<input type="checkbox"/> Sidewalk Waiver (Form V2)	<input type="checkbox"/> Sketch Plat Review and Comment (Form S2)
SITE PLANS	<input type="checkbox"/> Waiver to IDO (Form V2)	APPEAL
<input type="checkbox"/> DRB Site Plan (Form P2)	<input type="checkbox"/> Waiver to DPM (Form V2)	<input type="checkbox"/> Decision of DRB (Form A)
BRIEF DESCRIPTION OF REQUEST		
Final sign-off on a Site Plan - EPC for a 78 lot subdivision.

RE: **Catalonia Subdivision**
Tr 1 & 2, The Trails Unit 3A
Drainage Report Stamp Date: 9/16/19
Grading Plan Stamp Date: 9/16/19
Hydrology File: C09D013

**RE: Water and Sanitary Sewer Serviceability Letter #190126
Catalonia at the Trails
Woodmont Av. NW**

OFFICIAL NOTIFICATION OF DECISION

190126 - Water

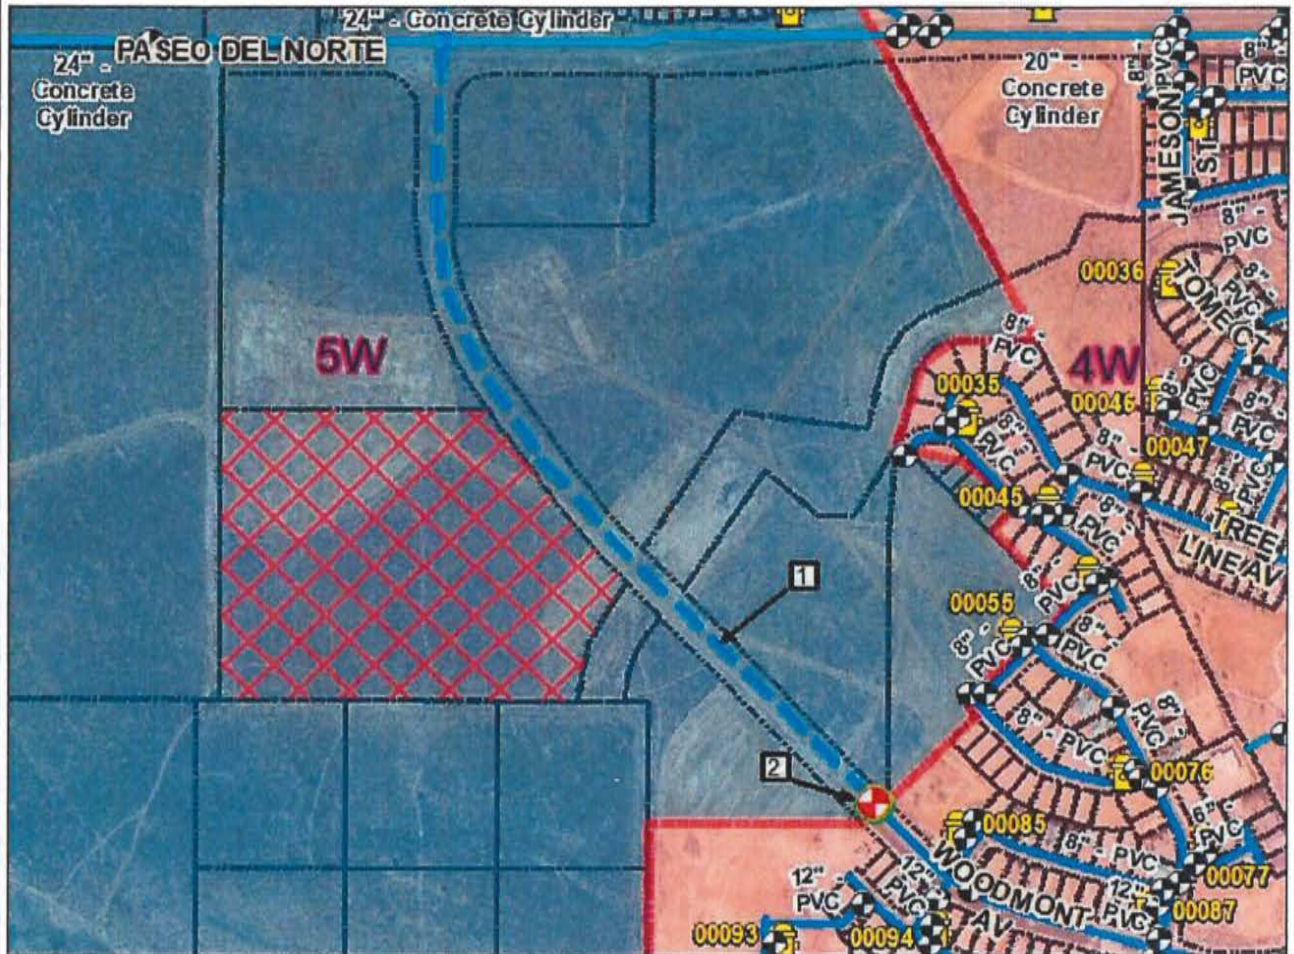
Water Service: There currently is no available service for Pressure Zone 5W. In order to receive service from Pressure Zone 5W, the development will be responsible for constructing and/or contributing towards a Pressure Zone 5W gravity system, which may include but is not limited to a reservoir, transmission line and possible pump station improvements. Currently, there is no approval to provide service to this proposed development from the existing 5W closed loop system.

The subject development will be required to install a 12 inch bottom of zone distribution main (5W) along Woodmont Ave., ultimately connecting to the existing 12 inch (4W) waterline located further south/east along Woodmont Ave. via a pressure reducing valve (PRV). The proposed 12 inch distribution main (5W) shall provide for looped waterlines within the proposed development. The proposed 12 inch waterline (5W) shall cover the entire property frontage along Woodmont Ave. and shall extend to Paseo Del Norte.

190126 - Sanitary Sewer

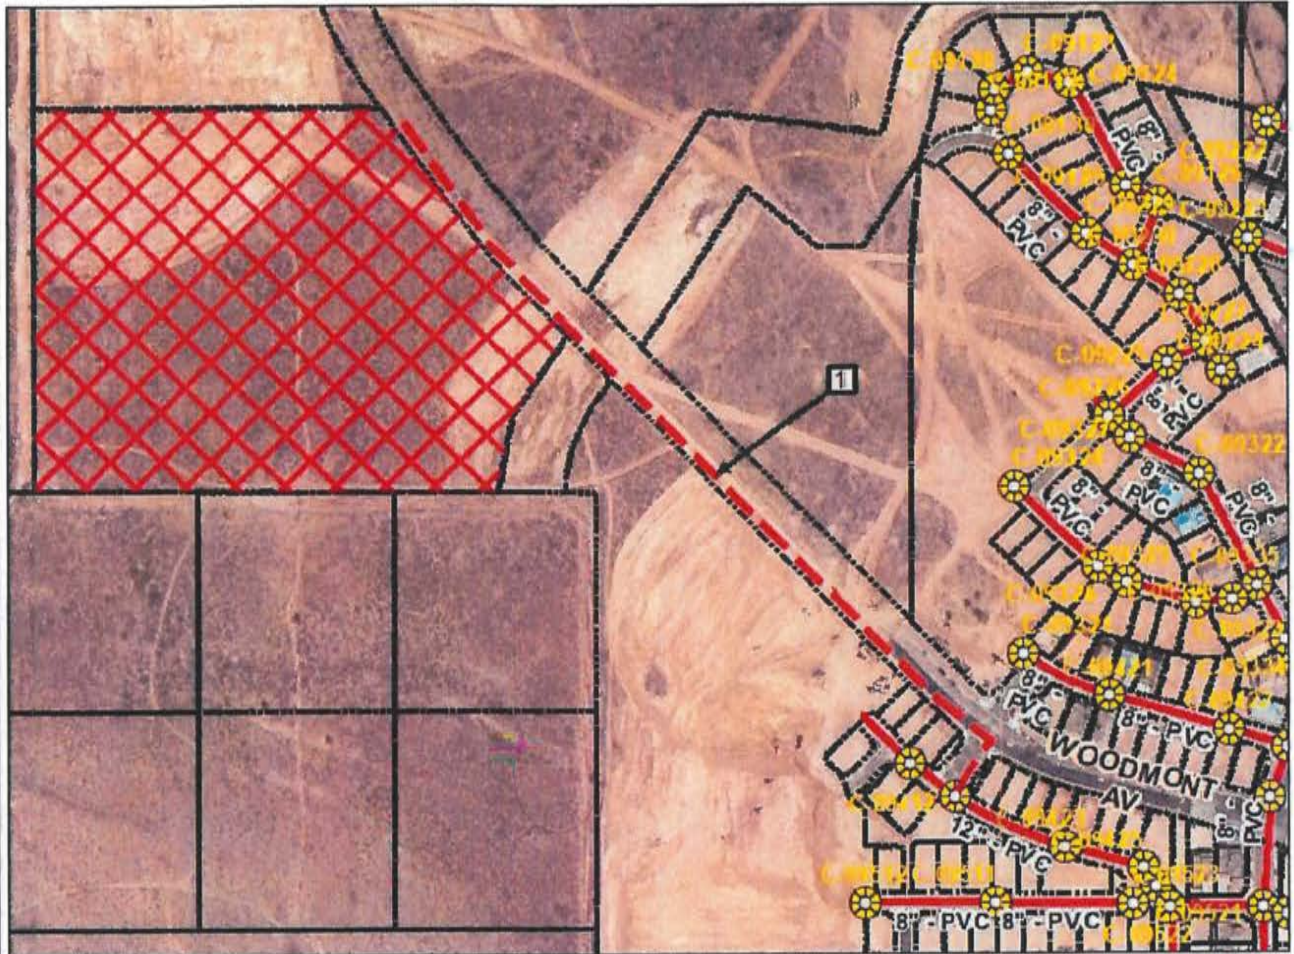
Sanitary Sewer Service: When water service is available, sanitary sewer service can be provided via a developer funded project which extends a 12 inch sanitary sewer line north/west along Woodmont Ave. from the existing 12 inch sanitary sewer along Window Peak Rd. The proposed extension shall be entirely within the Woodmont Ave. right-of-way and shall cover the entire property frontage. Public sanitary sewer collector lines shall extend within the proposed development which discharge to the proposed 12 inch sanitary sewer along Woodmont Ave.

CONCEPTUAL GRADING AND DRAINAGE PLAN

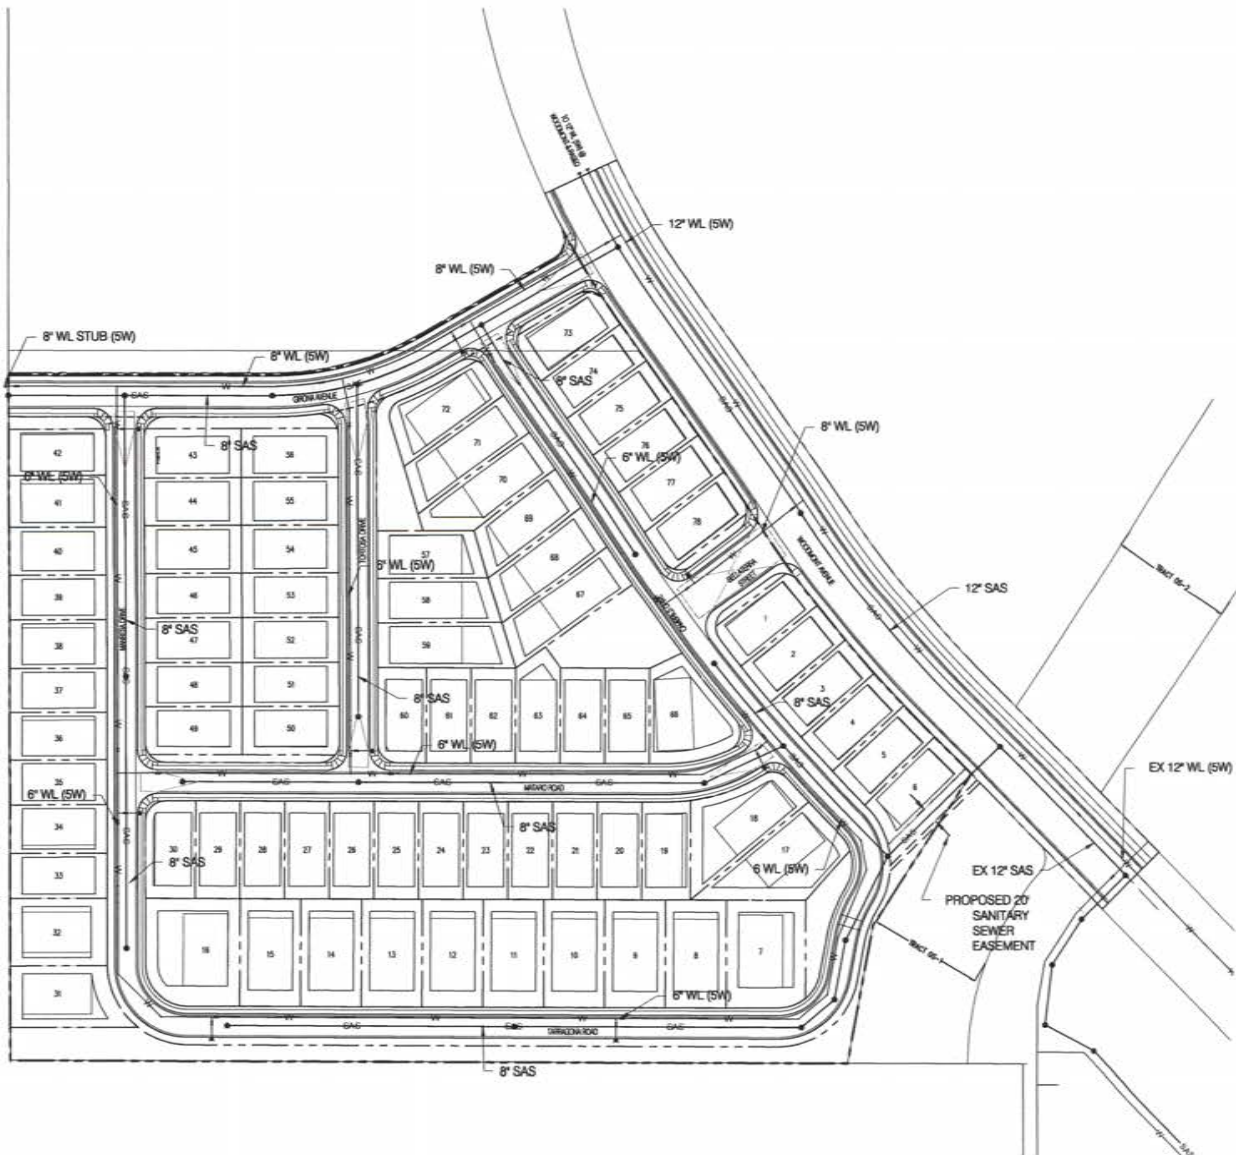
1. Offsite Pond 1.
 - a. Provide written and signed permission from the owner of *Portion of Tract 5 in the W/2 NE/4 NW/4 SEC 17 T11N R2E* for the grading and swale/pond construction on their property.

2. For Information. The following drainage infrastructure needs to be added/amended on the infrastructure list:
 - a. *6" diameter orifice plate on Pond B outfall.* This can be its own line item, or be added to the Pond B line item.

- b. *12" diameter orifice plate on Offsite Pond 1 outfall.* This can be its own line item, or be added to the Pond B line item.
3. For Information. Reduced waterblock heights will be allowed at: Matero & Manresa (0.24' min) and Bellaterra & Cambrils (0.15' min).

5. Provide dimensional data on plans (top width, bottom width, depth, etc.) for the spillways and swale.
6. Provide outlet structure detail for Offsite Pond 1 with 12" diameter orifice plate. Provide outlet structure detail for Pond B with 6" diameter orifice plate.
